NRC 2004-0054
10 CFR 50.55a(a)(3)

Point Beach Nuclear Plant, Unit 1
Docket 50-266
License No. DPR-24
NRC Order EA-03-009 Relaxation Request Supplement 2

RESPONSE TO REQUEST FOR ADDITIONAL INFORMATION NRC ORDER EA-03-009 RELAXATION REQUEST SUPPLEMENT 2

Figure 6-5

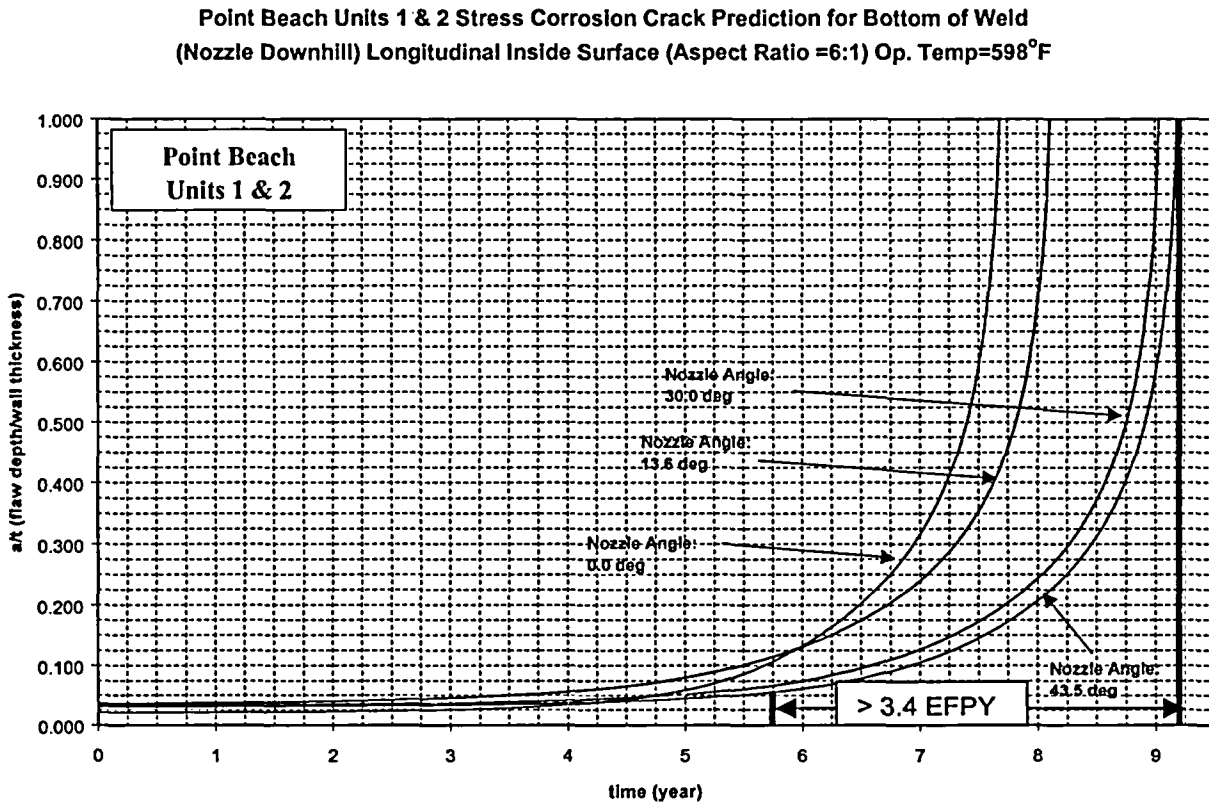
Figure 6-5 of WCAP-14000 is reproduced below. This figure represents a crack growth prediction for axial inside surface flaws near the attachment weld on the downhill side. The 43.5° curve is used. The flaw aspect ratio is 6:1. For an initial a/t value of 0.06, a flaw would require over 3.4 EFPY to reach a through-pressure boundary of 1.0 a/t.

PBNP operates on an 18-month cycle and will be replacing the RPV head during the next refueling outage scheduled for fall 2005. Unit 1 operation following the fall 2002 refueling outage (initiation time of the postulated flaw) and the replacement of the RPV head will not exceed 2.8 EFPY. Therefore, a worst-case flaw could not progress through-wall during the next Unit 1 operating cycle.

Figure 6-7

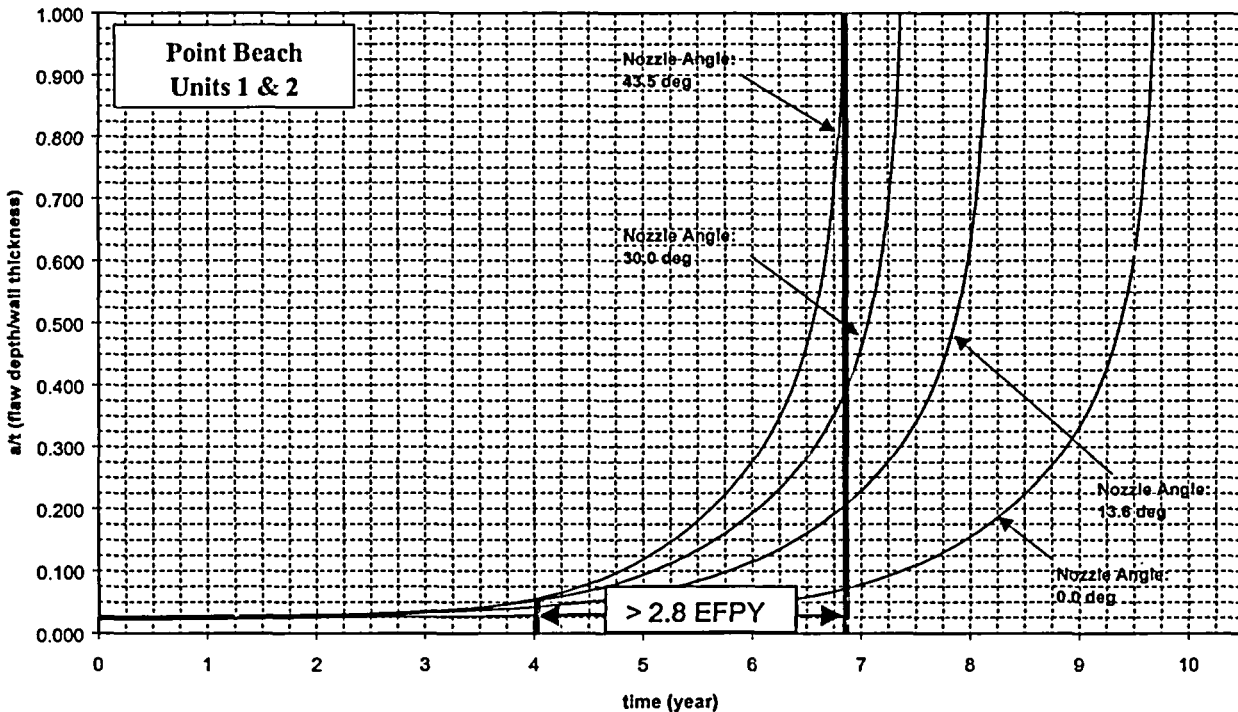
Figure 6-7 of WCAP-14000 is reproduced below. This figure represents a crack growth prediction for axial inside surface flaws above the attachment weld on the downhill side. The 43.5° curve is used. For an initial a/t value of 0.06, a flaw would require over 2.8 EFPY to reach a through-pressure boundary of 1.0 a/t.

Figure 6-13

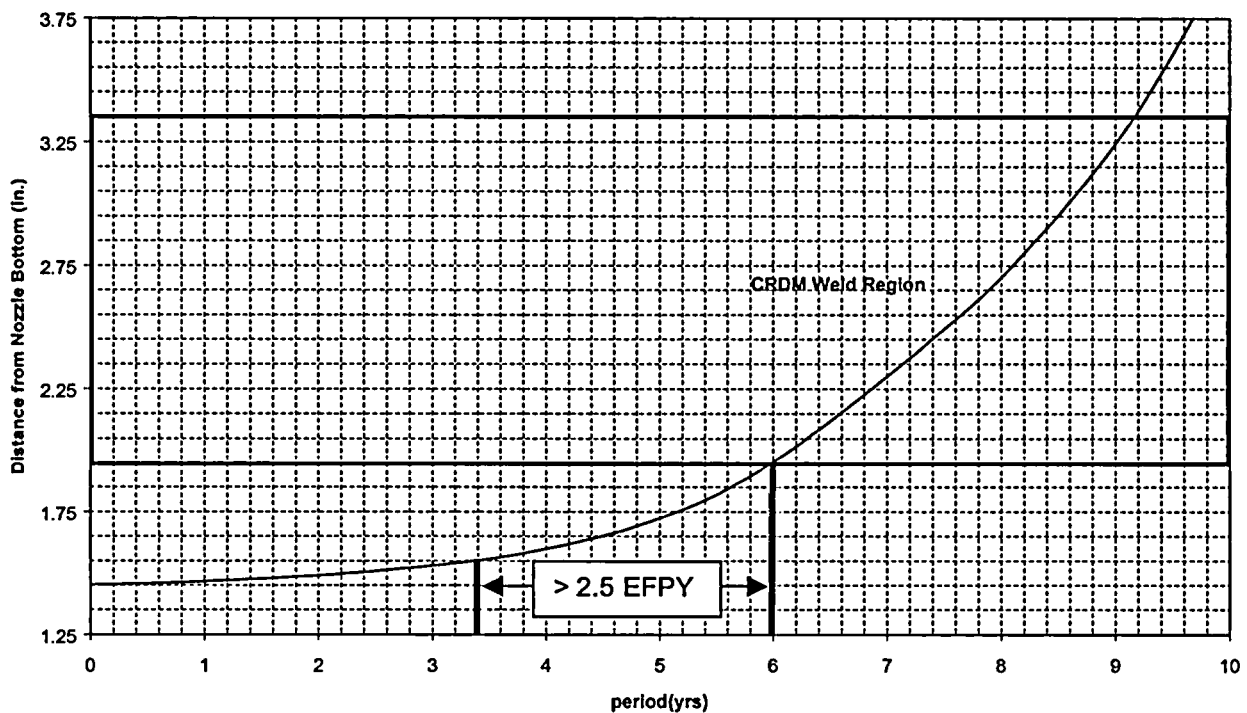
Figure 6-13 of WCAP-14000, shown below, is a crack growth prediction for through-wall axial flaws located in the 30.0° penetration ring. Nozzle 20 is the limiting nozzle for this assessment and is also located in the 30.0° penetration ring. As shown below, the assumed through-wall flaw would take over 2.5 EFY to reach the J-groove weld.

PBNP operates on an 18-month cycle and will be replacing the RPV head during the next refueling outage scheduled for fall 2005. Therefore, a worst-case flaw could not progress sufficiently to reach the J-groove weld during the next Unit 1 operating cycle. Thus, the values used in our calculation are considered appropriate and conservative.
